ISCS - Feature #704

line3# 1500V

- Subject changed from line3# to line3# 1500V

20200814161405.jpg

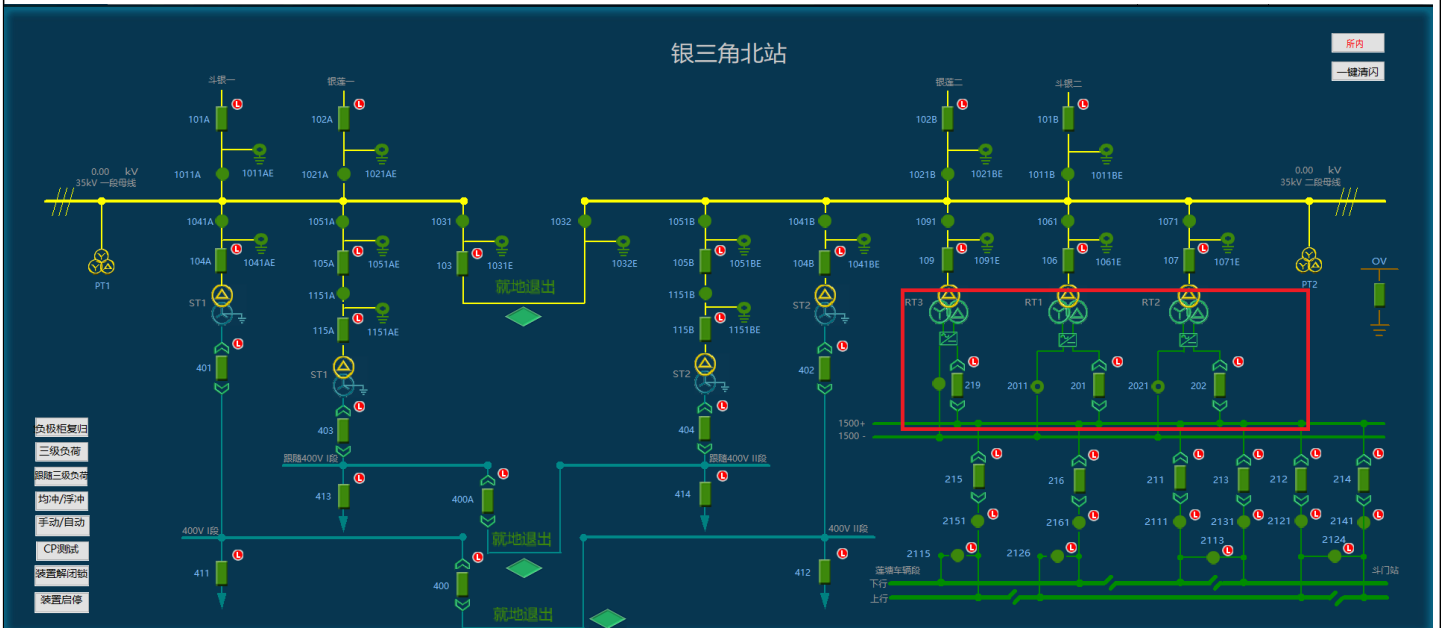
▪ **2.2. 1500V进线一键停送电控件界面** 整流有三个

▪ **2.3. 基于图1控件的结构，将控制选择框和操作内容框中的选项进行变更。**

控制选择框中保持原有按钮的数量和颜色，将按钮的文字提示进行修改。将“上、下行送电”修改为“1、2号整流进线送电”；将“下行送电”修改为“2号整流进线送电”；将“上行送电”修改为“1号整流进线送电”；将“上、下行停电”修改为“1、2号整流进线停电”；将“下行停电”修改为“2号整流进线停电”；将“上行送电”修改为“1号整流进线停电”。将“全线上、下行送电”修改为“全线1、2号整流进线送电”；将“全线上、下行停电”修改为“全线1、2号整流进线停电”。

操作内容框中保持原有的文本框和按钮，文本框中“区段”字段的内容显示所选起始车站至终点车站，文本框中“操作内容”字段显示控制选择框中选择的控制内容。

送电及停电操作应当至少支持2组断路器及隔离开关分合闸。

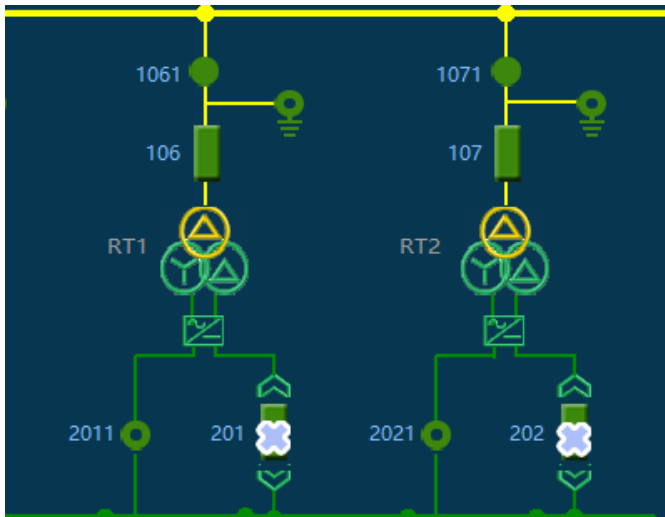
in_jxtdNC3.dll,DCjinxian.ini

[NC3DCtrain] --->
TIMECHECKCMD=50 ---->
BKCOLOR=7,54,80 ----->
TEXTCOLOR=138,169,177 ---->UI

COUNT=13 -->
0= -->
1=
2=
3=
4=
5=
6=
7=
8=

9=00000
10=00000
11=00000
12=00000
13=000000

{00000}
GROUPCODE=ELZ -->00000
XX_SUPPLYZONENO=XX10 -->00000000
SX_SUPPLYZONENO=SX10 -->00000000
RT1_UP=ELZ_1500V_211_ZT --->RT1000000
RT1_DOWN=ELZ_GLP600_2111_ZT --->RT1000000
RT1_LEFT=ELZ_1500V_212_ZT -->RT1000000
RT1_RIGHT=ELZ_GLP600_2112_ZT -->RT1000000
RT2_UP=0 -->00000000,00000000000.000
RT2_DOWN=0
RT2_LEFT=0
RT2_RIGHT=0
RT3_UP=0
RT3_DOWN=0
RT3_LEFT=0
RT3_RIGHT=0
